# Jan 2026 MDG Proposed Updates

Revision Type	Reference	Section Description (Red indicates Change of name from existing)	Description of Revision	New or Deletion	Primary POC
MDG	ALL Chapters	Many	Editorial update throughout MDG to change "Shared Use" to "Shared-Use" to be consistent with MUTCD		Alford / Fiant
MDG	ALL Chapters	Many	Revised uses of "shared lane" and replaced with "shared-lane" to be consistent with usage in MUTCD		Alford
MDG	1.4	Definitions	Updated definitions for consistency with MUTCD		Alford
MDG	2.3.1.1	Planning Resources	Updated Streetlight Data Row to indicate account access provided through Office of Planning rather than Office of Roadway Engineering. Also, removed safety data available timeframe years in Walk.Bike.Ohio row.		Alford
MDG	Table 3-2	Mean Walking Speeds for Disabled Pedestrians and Users of Various Assistive Devices	Corrected walking speed for Above-knee amputee row in table		Alford
MDG	Figure 3-3	Example of Mutual Yielding Zones Illustrating Intersection Sight Distance Case A	Update figure to show current MUTCD bike symbol marking		Alford

**Figure 3-4: Intersection Sight Distance Bike Case B**

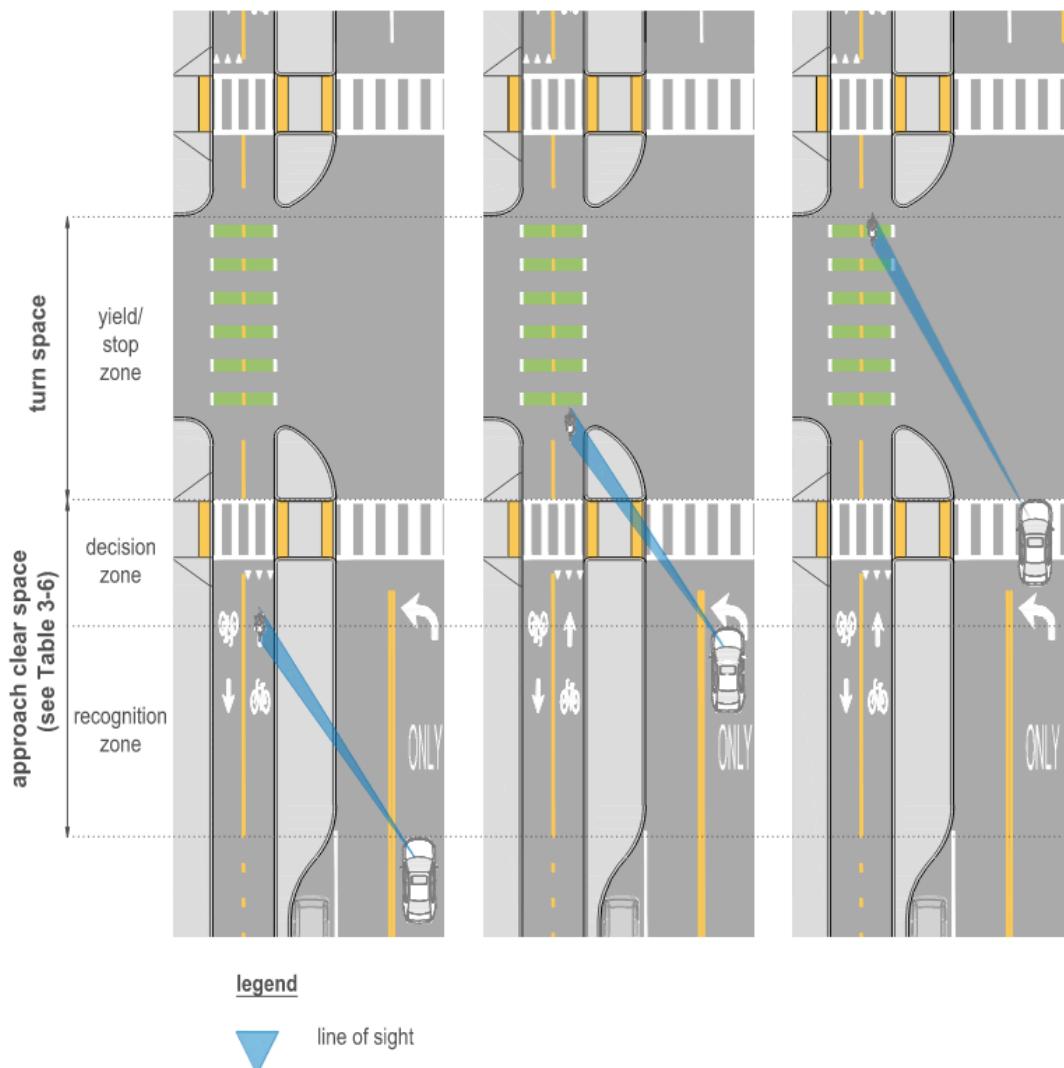
MDG	Figure 3-4	Intersection Sight Distance Bike Case B	Update figure to show current MUTCD bike symbol marking		Alford
MDG	Figure 3-5	Intersection Sight Distance Bike Case C1 – Two-Stage Crossing Scenario	Update figure to show current MUTCD bike symbol marking. Also update the figure legend.		Alford
MDG	Figure 3-6	Intersection Sight Distance: Bike Case C1 – Single Crossing Scenario	Update figure to show current MUTCD bike symbol marking		Alford
MDG	Figure 3-7	Intersection Sight Distance Case C2	Update figure to show current MUTCD bike symbol marking		Alford
MDG	Figure 3-12	Pedestrian Crossing Shared-use Path or Separated Bikeway (shown) Sight Triangle	Update figure to show current MUTCD bike symbol marking		Alford
MDG	Figure 3-13	Spatial Dimensions for People Using Typical Mobility Devices	Revise to change the 72" Max vertical dimension to be 80" Min		Alford
MDG	3.6.2	Shy Spaces	Update the "Intermittent Vertical Elements" section to reword mention of OMUTCD and associated language		Alford

**Figure 4-6d: Potential Treatments for Mid-block Crossings with PHB (5-lane section with existing drives and greater than 35 MPH posted speed)**

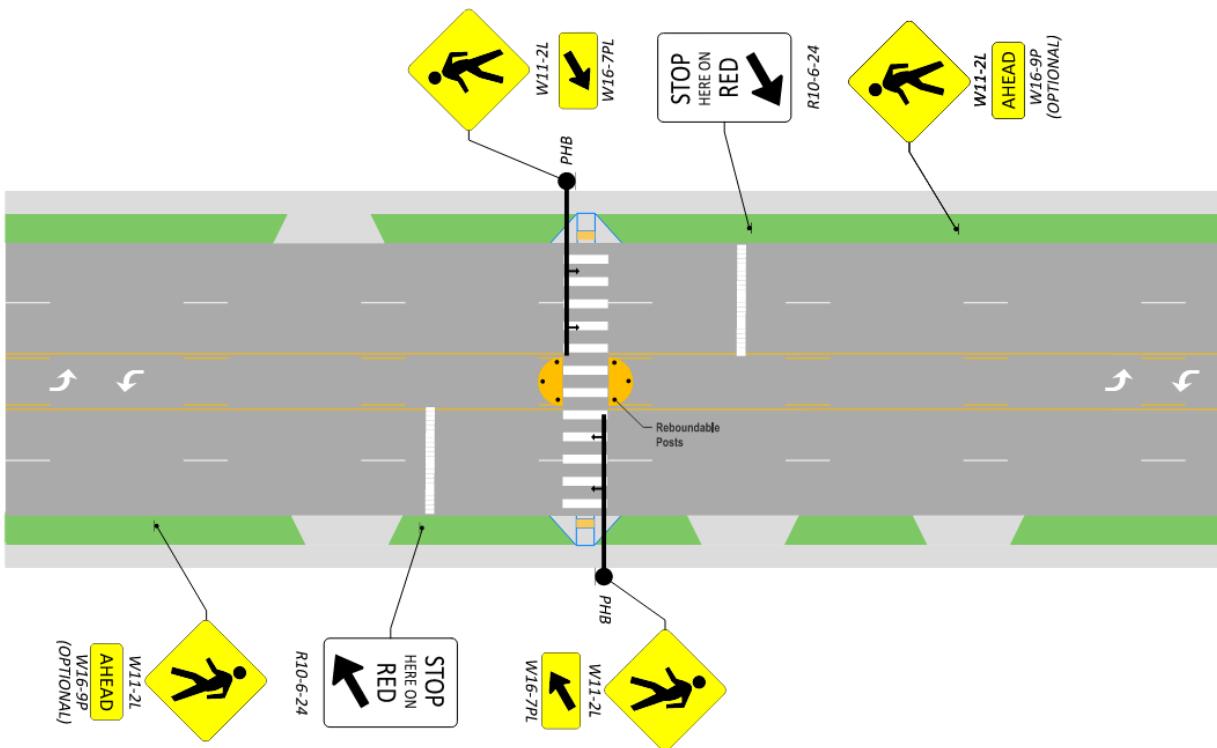
Revision Type	Reference	Section Description (Red indicates Change of name from existing)	Description of Revision	New or Deletion	Primary POC
MDG	Figure 4-6d	Potential Treatments for Mid-block Crossings with PHB (5-Lane section with existing drives and greater than 35 MPH posted speed)	Update figure to correct sign colors to make the warning signs black on yellow rather than black on white		Alford
MDG	4.5.1.1	Crosswalk Markings	Update MUTCD references and associated TEM references. Update language related to High-Visibility (longitudinal) crosswalk markings to be consistent with MUTCD and TEM.		Alford
MDG	4.5.1.2	Yield Markings	Update MUTCD references		Alford
MDG	4.5.5	Raised Crossings	Updated bullet point referencing "Raised Crosswalk" sign to indicate "Speed Hump" sign		Alford
MDG	4.8	Work Zones	Updated OMUTCD references		Alford
MDG	Figure 5-9	Shared-Use Path Stops or Yields	Update Figure Reference to be call out OMUTCD Table 2C-3 (instead of Table 2C-4)		Alford

**Figure 5-10: Shared-use Path Stops or Yields near Railroad Crossing**

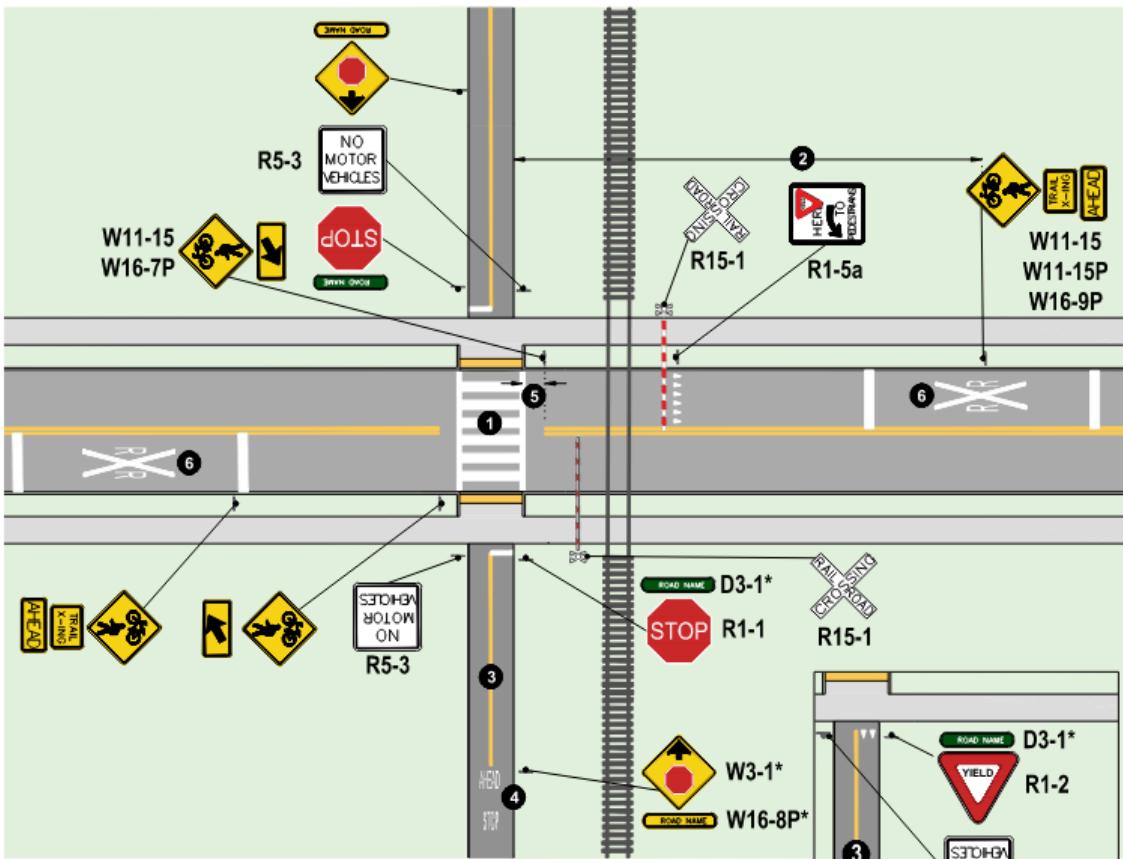
MDG	Figure 5-10	Shared-Use Path Stops or Yields near Railroad Crossing	Update Figure Reference to be call out OMUTCD Table 2C-3 (instead of Table 2C-4)		Alford
MDG	Figure 5-11	Road Stops	Update Figure Reference to be call out OMUTCD Table 2C-3 (instead of Table 2C-4)		Alford
MDG	Figure 5-12	Multi-lane Road Uncontrolled with Advance Yield Line	Update Figure Reference to be call out OMUTCD Table 2C-3 (instead of Table 2C-4)		Alford
MDG	5.7.1	Signs and Traffic Control	Update OMUTCD reference		Alford
MDG	5.7.2	Pavement Markings	Update OMUTCD reference		Alford
MDG	5.8	Shared Use Paths - Use of Limited Access Right of Way	New section providing guidance if considering a SUP within limited access right of way	New	Alford
MDG	6.2	On-Road Bicycle Facilities - Bicycle Routes	Add an additional bullet point under Signing and Markings to recommend to bicycle facility owners of non-numbered Bicycle Routes utilize the Non-Numbered Bicycle Route Signs as described in OMUTCD 9D.06.		Fiant

**Figure 6-1: On-Road Bikeway Types**

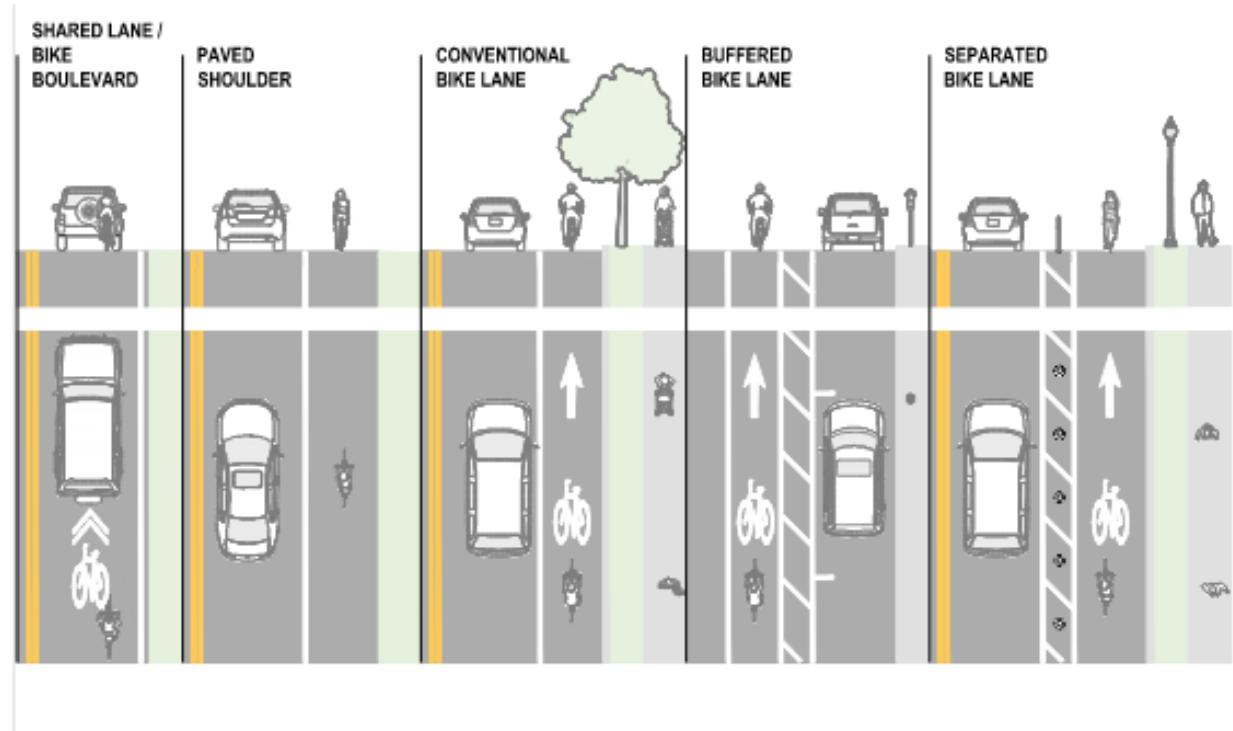
MDG	Figure 6-1	On-Road Bikeway Types	Update figure to show new Bike Symbol per MUTCD		Alford
MDG	6.3.1	Shared-Lanes	Update speed criteria and also update OMUTCD references. Update Shared Lane Signs section to refer to use of R4-19 Bicycle Passing Clearance sign and updated info related to "IN ROAD" plaque rather than "SHARE THE ROAD" plaque. Other clarifying updates for consistency with MUTCD.		Alford
MDG	Figure 6-2	Shared-Lane Markings Lateral Placement	Update R9-20 sign image for clarity and consistency with MUTCD		Alford
MDG	Figure 6-3	Longitudinal Placement and Intersection Navigation Examples of Shared-Lane Markings along a Roadway	Update figure to remove shared lane intersection guide markings per Section 9E.09 P 04 line B.		Alford
MDG	6.3.4	Bicycle Lanes	Under header, "Bicycle Lanes on One-Way Streets" added clarifying language for counter-flow bike lane and also updated OMUTCD references. Added clarifying language addressing "EXCEPT BICYCLES" plaque. Removed reference to experimentation for use of Green Colored pavement (this is now standard element in MUTCD).		Alford

**Figure 6-6: Typical Bike Lane Pavement Markings and Traffic Control Signs**

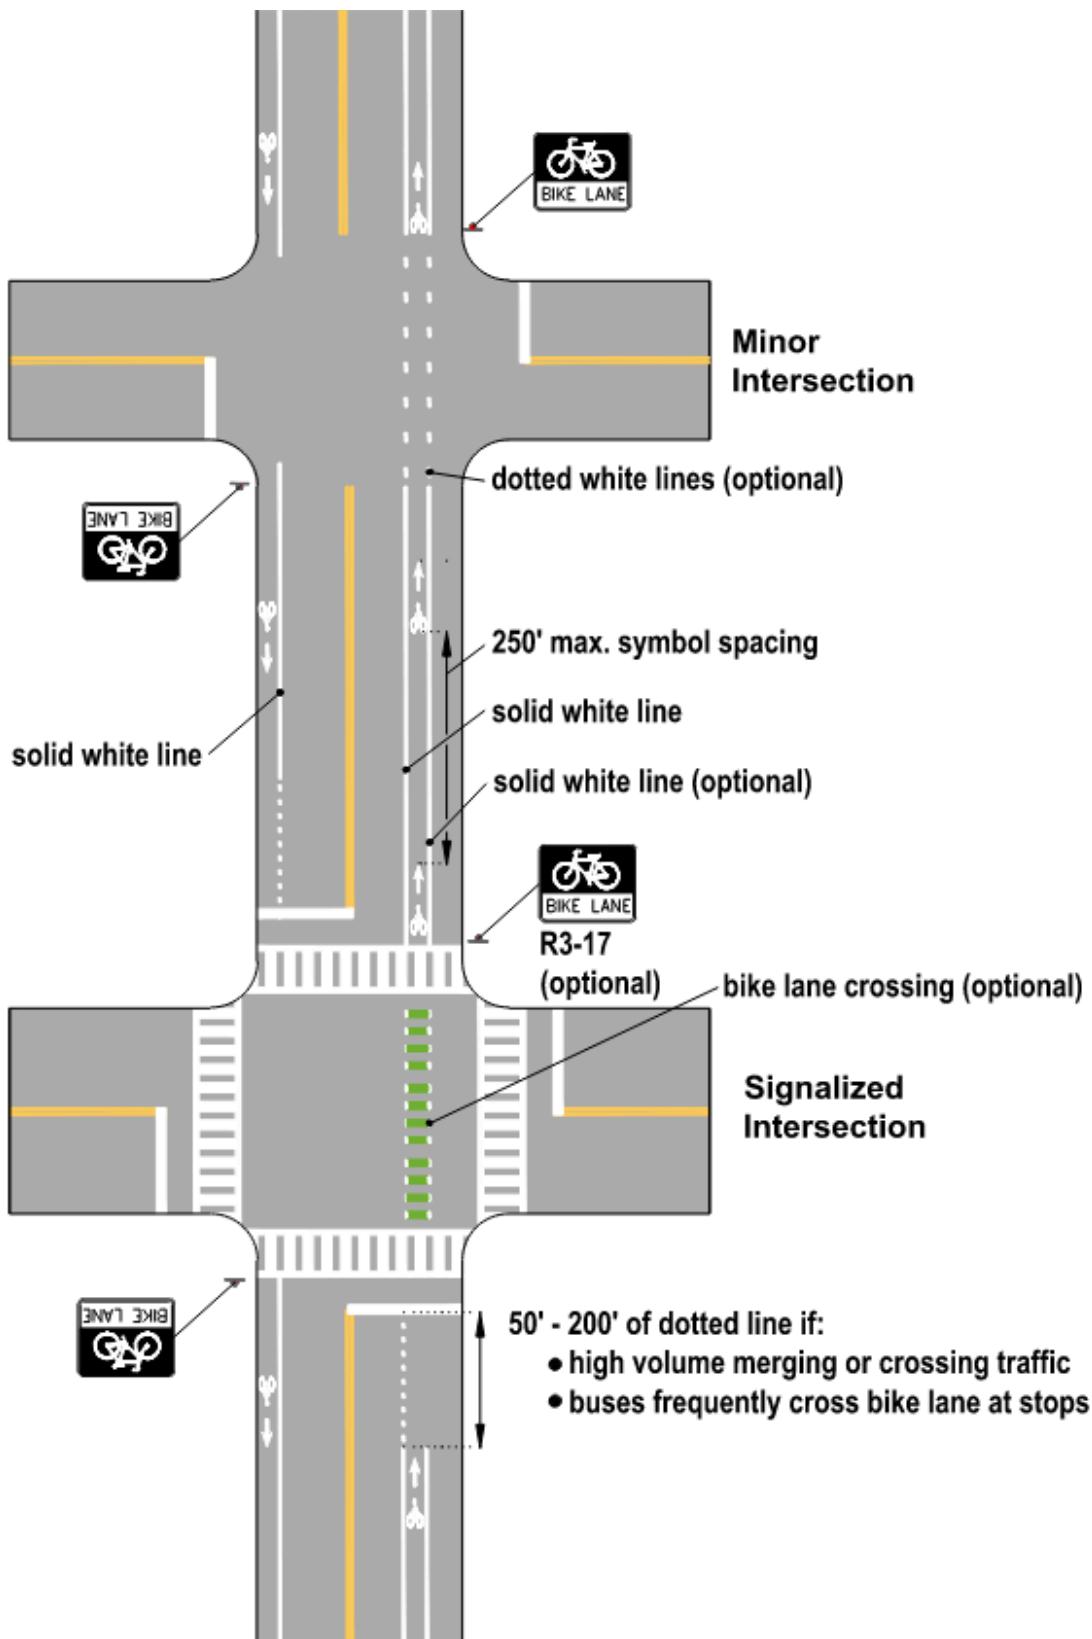
MDG	Figure 6-5	Shared-Lane Marking and Bike Lane on Steep Street	Update figure to show new Bike Symbol per MUTCD		Alford
MDG	Figure 6-6	Typical Bike Lane Pavement Markings and Traffic Control Signs	Update figure to show new Bike Symbol per MUTCD		Alford
MDG	Figure 6-7	Example of Door Zone Markings in Constrained Bike Lane Conditions	Update figure to show new Bike Symbol per MUTCD		Alford
MDG	Figure 6-8	Design Criteria for Back-in Angled Parking	Update figure to show new Bike Symbol per MUTCD		Alford

**Figure 6-20: Transition from One-Way to Two-Way Separated Bike Lanes with Two-Stage Turn Box**

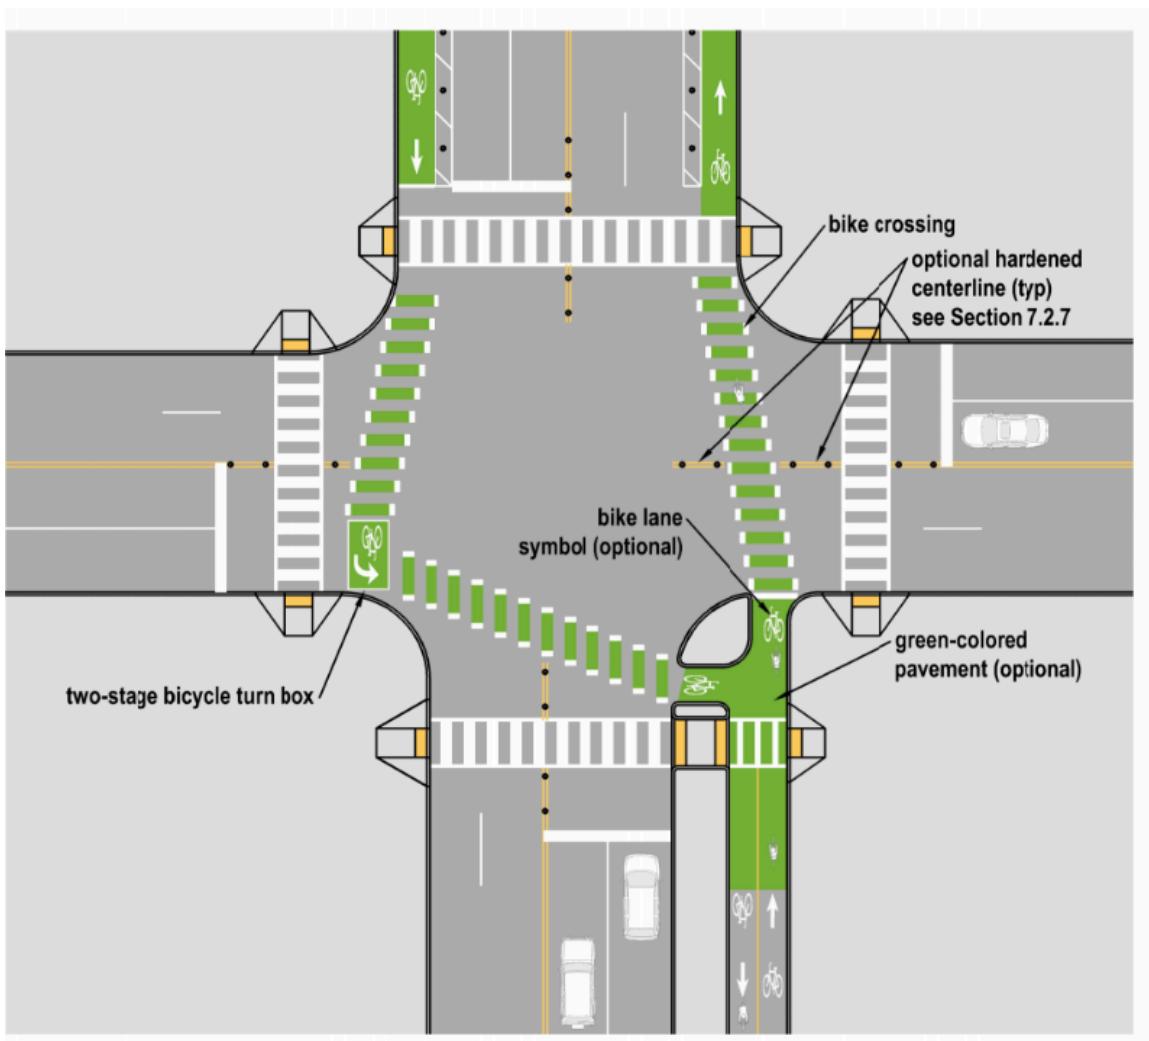
MDG	Figure 6-20	Transition from One-Way to Two-Way Separated Bike Lanes with Two-Stage Turn Box	Update figure to show new Bike Symbol per MUTCD and remove reference to Interim Approval for Green Colored Pavement and Two-Stage Bicycle Box		Alford
MDG	Figure 6-21	Transitions between Offset Intersections with Two-Way Separated Bike Lanes	Update figure to show new Bike Symbol per MUTCD and remove reference to Interim Approval for Green Colored Pavement and correct TWLTL markings		Alford
MDG	Figure 6-25	Example of Bikeshare Stations Installed Within a Roadway	Update figure to show new Bike Symbol per MUTCD		Alford
MDG	6.5.1	General Bikeway Design at Intersections & Crossings	Updated language related to supplemental use of green colored pavement to be consistent with MUTCD. Also updated language related to Two-Stage Bike Turn Box to remove reference of needing experimental approval and added additional clarifying language on two-stage turn box use. Other clarifying updates in "Bike Boxes" section.		Alford

**Figure 6-26: Bicycle Crossing Pavement Markings**

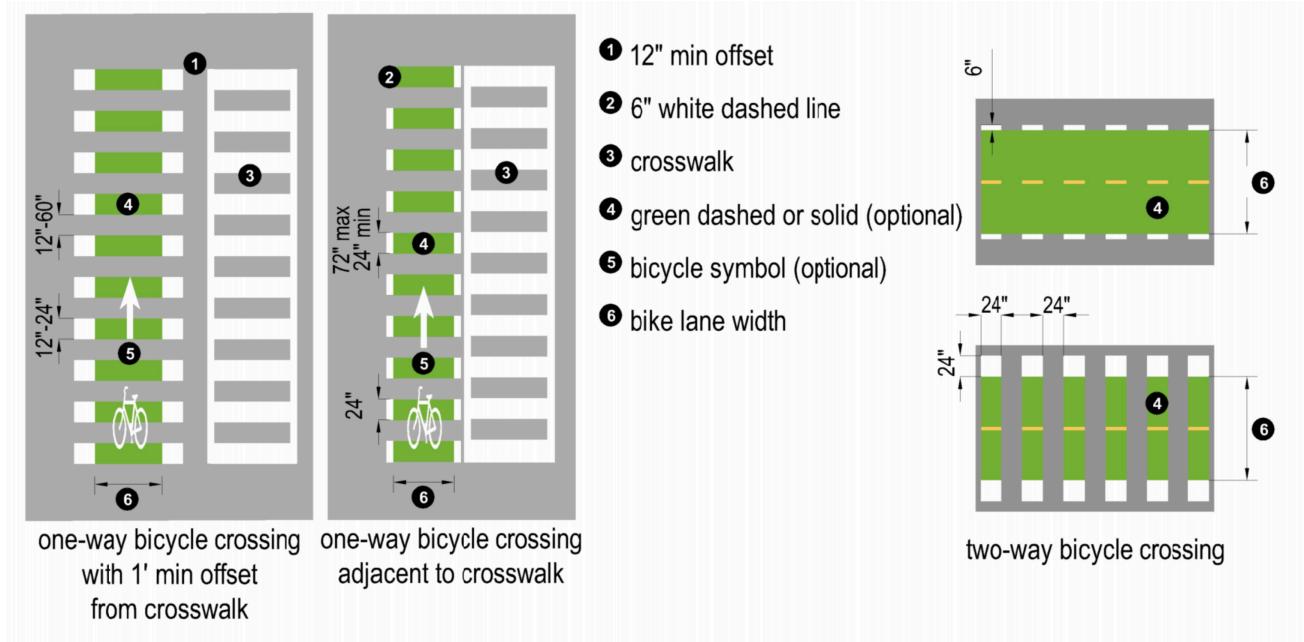
MDG	Figure 6-26	Bicycle Crossing Pavement Markings	Update figure to show new Bike Symbol per MUTCD and remove reference to Interim Approval for Green Colored Pavement and correct dotted bike crossing markings		Alford
MDG	Figure 6-27	Two-Stage Bike Turn Box Pavement Markings	Update figure to show new Bike Symbol per MUTCD and remove reference to Interim Approval for Green Colored Pavement and also update bottom left example		Alford
MDG	Figure 6-28	Two-Stage Left Turn Box Placement	Update figure to show new Bike Symbol per MUTCD and remove reference to Interim Approval for Green Colored Pavement and Two-Stage Bicycle Box		Alford
MDG	Figure 6-29	Bicycle Box Configuration Across One Lane of Through Traffic	Update figure to show new Bike Symbol per MUTCD and remove reference to Interim Approval for Two-Stage Bicycle Box. Also add green colored markings on this Figure		Alford
MDG	Figure 6-30	Protected Intersection Design Components	Update figure to show new Bike Symbol per MUTCD and remove reference to Interim Approval for Green Colored Pavement		Alford

**Figure 6-32: Separated Bike Lane to the Left of a Right-Turn Lane (left) or Transitioning to a Shared Right-Turn Lane (right)**

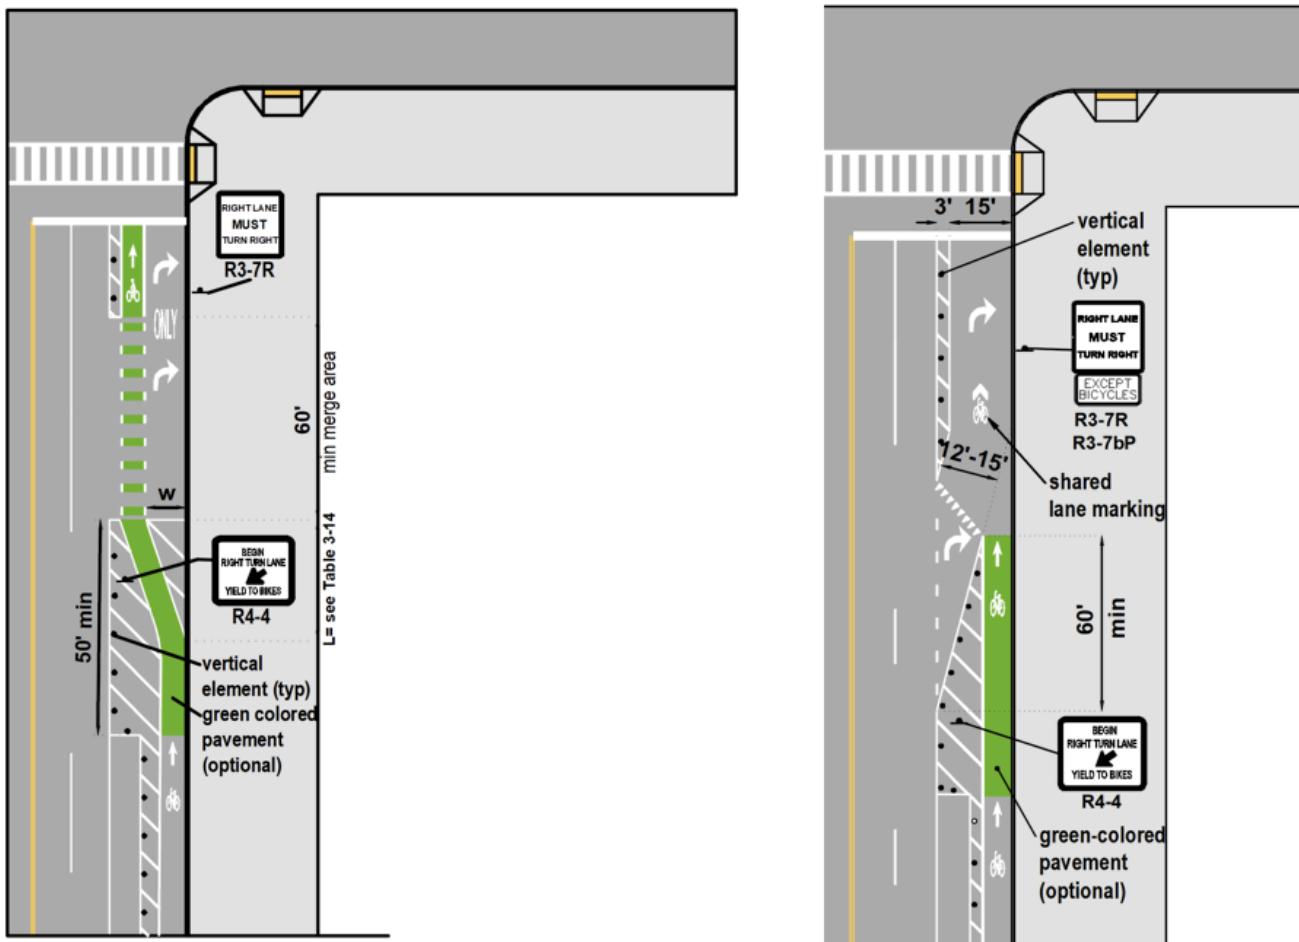
MDG	Figure 6-32	Separated Bike Lane to the Left of a Right-Turn Lane (left) or Transitioning to a Shared Right Turn Lane (right)	Update figure to show new Bike Symbol per MUTCD and remove reference to Interim Approval for Green Colored Pavement		Alford
